### APPEAL SUMMARY

<b>Appeal ID:</b> 15711	<b>Project Address:</b> 4336 NE 18th Ave
<b>Hearing Date:</b> 8/23/17	<b>Appellant Name:</b> Max Baertlein
<b>Case No.:</b> P-002	<b>Appellant Phone:</b> 5039147576
<b>Appeal Type:</b> Plumbing	<b>Plans Examiner/Inspector:</b> Jacob Carringer
<b>Project Type:</b> residential	<b>Stories:</b> 3 <b>Occupancy:</b> 1 & 2 Family Dwelling <b>Construction Type:</b> Wood
<b>Building/Business Name:</b>	<b>Fire Sprinklers:</b> No
<b>Appeal Involves:</b> Alteration of an existing structure, Correction of a violation	<b>LUR or Permit Application No.:</b> 16-146398-RS,
<b>Plan Submitted Option:</b> pdf [File 1] [File 2]	<b>Proposed use:</b> Single Family Home

#### Appeal item 1

## APPEAL DECISION

INSPECTION REPORT

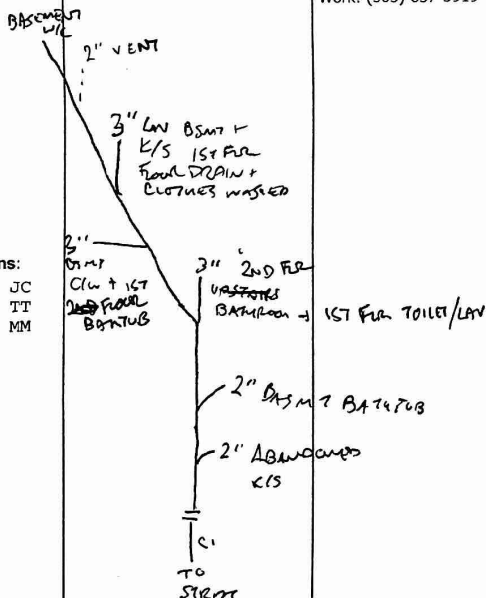
- ① PROVIDE DOCUMENTATION THAT PIPING IN BASEMENT FLOOR IS ~~BELOW~~ AT OR ABOVE LEVEL OF MANHOLE COVER AT PRESCOTT + 18TH
- ② IF PIPING IN FLOOR IS BELOW LEVEL OF MANHOLE COVER, THEN NEED BACKWATER VALVES ON DRAIN LINES SERVING BASEMENT FIXTURES. 1ST/2ND FLOOR FIXTURES CAN NOT DRAW THROUGH BACKWATER VALVE. BACKWATER VALVE ON ABOVE GROUND DRAIN LINES (TRAP ARM) OF LAV BASIN + CLOTHES WASHER. VALVE IN FLOOR ON DRAIN LINES AT SHOWER, FLOOR DRAIN, + TOILET (5 TOTAL)

**Install backwater valve to serve entire house: Granted as proposed.**

**Note: The City is not responsible for damages incurred as a result of flooding due to installation of backwater valve, and that installation may not prevent any fixtures above upstream manhole from discharging or back flowing through fixtures below upstream manhole.**
